GARD response to
Thames Water's Consultation on
Draft
Water Resource Management Plan 2024

21st March 2023

GARD response to consultation on Thames Water’s draft WRMP24

Figure 28 - GARD proposed measures for the London baseline deficit

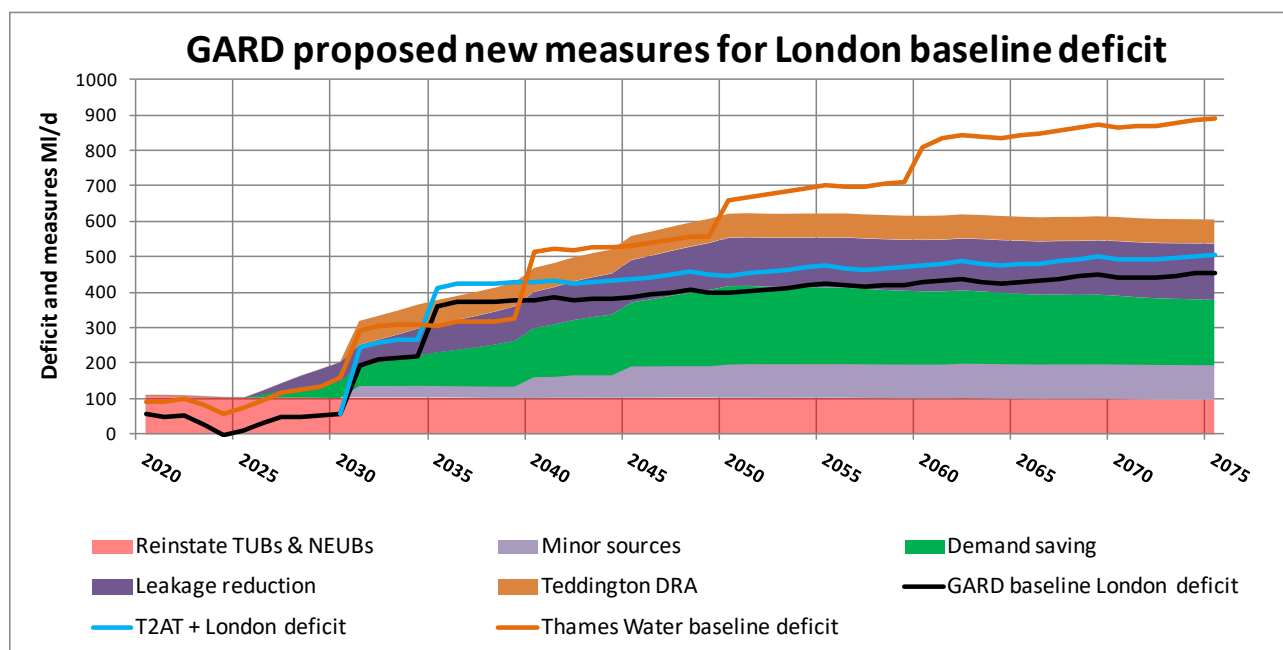
Figure 28 shows that neither Abingdon reservoir nor the Severn to Thames transfer is required to meet the needs of London and Affinity Water, even bringing forward the 1:500 year resilience to 2035, apart from a small deficit between 2035 and 2040. Moreover, it should be noted that in the balance shown in Figure 28, no allowance has been made for additional recovery of deployable output from enhanced chalk stream flows, as discussed in Section 3.4.2. Nor has there been any allowance for the London recovery of deployable output from the 35 Ml/d loss of deployable output from Farmoor reservoir due to restriction of its refilling (see Section 2.3.3).

Even without either Abingdon reservoir or the Severn to Thames transfer, Figure 28 shows that there would be a surplus of about 150 Ml/d in London's supplies continuously from 2040, if leakage and PCC reduction are on a trajectory to meet the Government targets by 2050. This shows the danger of creating a costly and environmentally damaging white elephant, if a decision to build Abingdon reservoir is made in the current cycle of business planning.

Figure 30 - Embedded or capital carbon budget

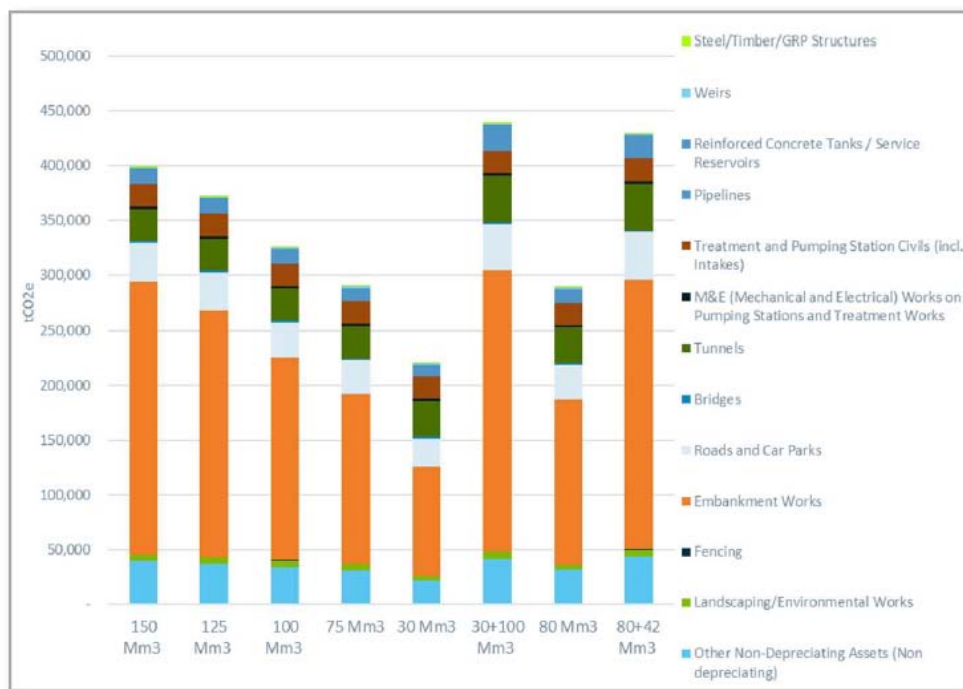
As the RAPID Gate 2 report on the Abingdon Reservoir shows⁸², the various versions of the project have the Embedded carbon breakdown as Figure 30. The carbon footprint is dominated by the construction of the embankment works, which includes all earth moving equipment emissions and transport to site of materials such as rip-rap. This forms about 70% of the 150Mm³ version and around 60% for the Best Value Plan choice of the 100 Mm³ version.

Figure 31 - Lifetime operational carbon budget of the Reservoir variants

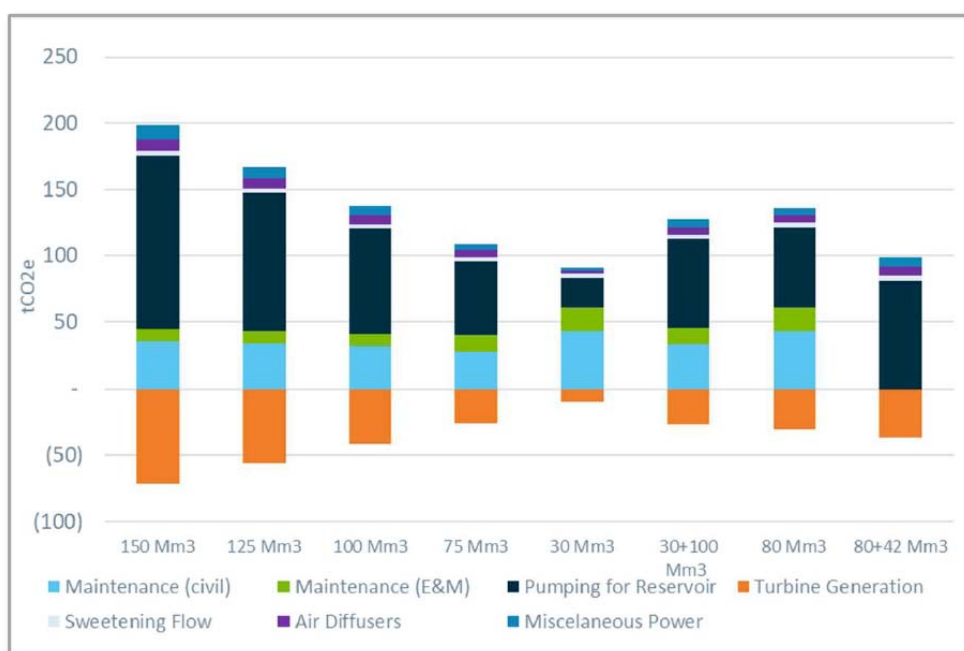
Operational carbon is low for the Reservoir and is shown in Figure 31 (copied from figure 6.2 of the Gate 2 report). The carbon budget is dominated (66%) by the energy needed to pump the water from the River Thames into the Reservoir. This energy is partially recovered by using low-head electricity generation turbines on the release of the water. Of course, with the intermittent use of the Reservoir, this is a balance over the lifetime of the Reservoir, rather than a within-year balance, but the comparison over the ‘lifetime’ (calculated over 2022-2101) is a valid one.

Figure 34 - Pywr assessed deployable outputs for STT variants and support sources

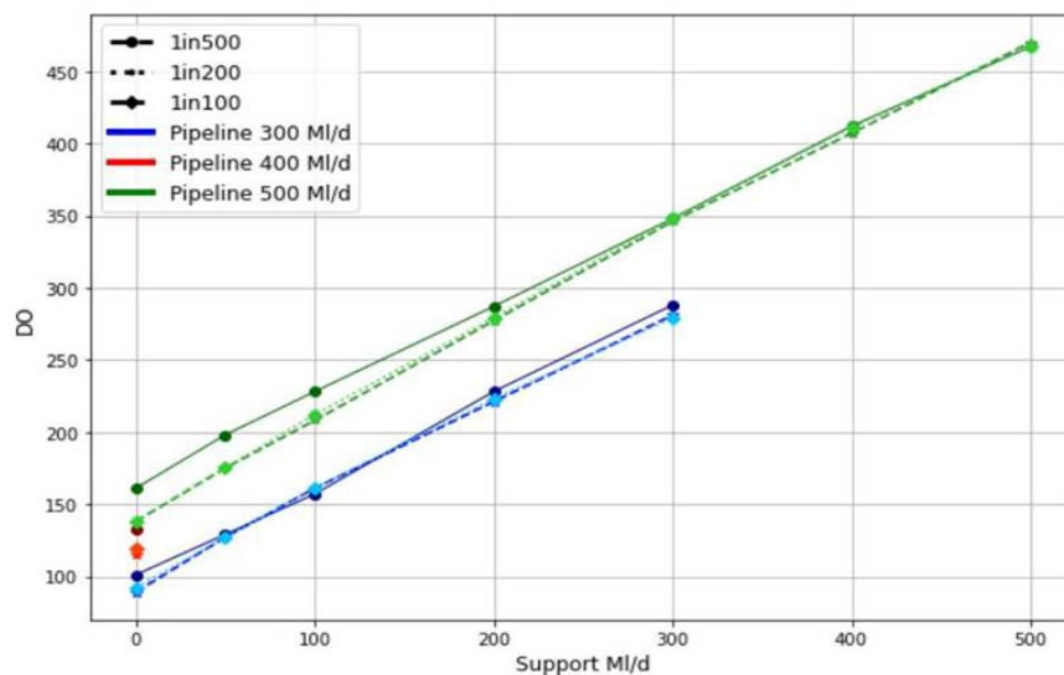
We have some initial comments on the DO assessments shown in Figure 30:

2. We are surprised at the sequence of introduction of support sources shown in the table in Figure 20. We would have expected the Minworth support to have been introduced before the Vyrnwy support option, bearing in mind that enhanced treatment of Minworth effluent is proposed in AMP8 to provide support water for the Grand Union Canal transfer.
